**Errata to ASHRAE Pocket Guide for Air Conditioning, Heating, Ventilation, Refrigeration  
(SI Edition)**

**January 16, 2008**

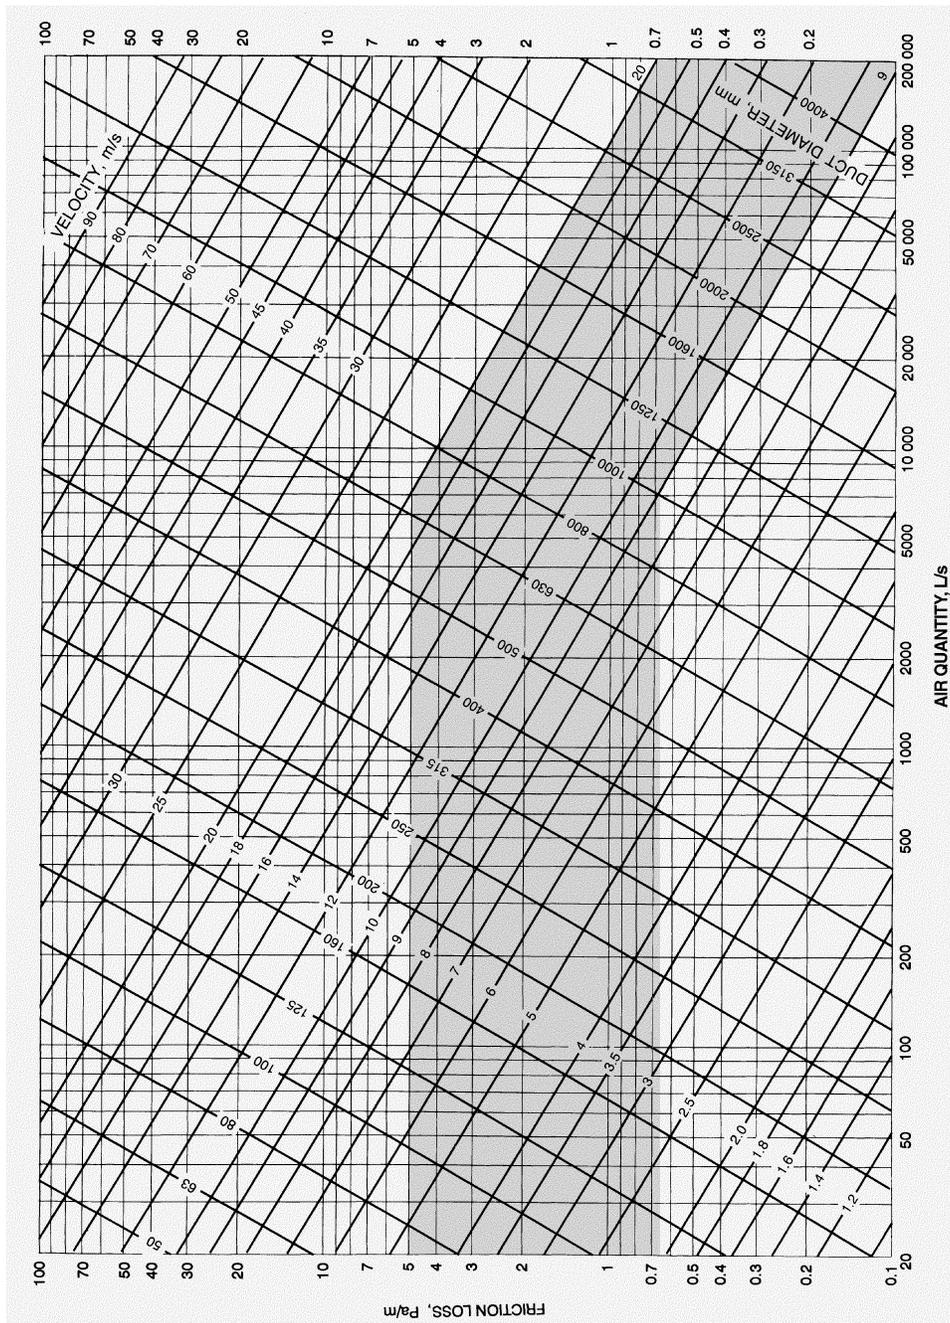
**I-3** The graphs on these pages should be replaced with the single following graph, as data are missing for flow rates between 500 and 1000 L/s.
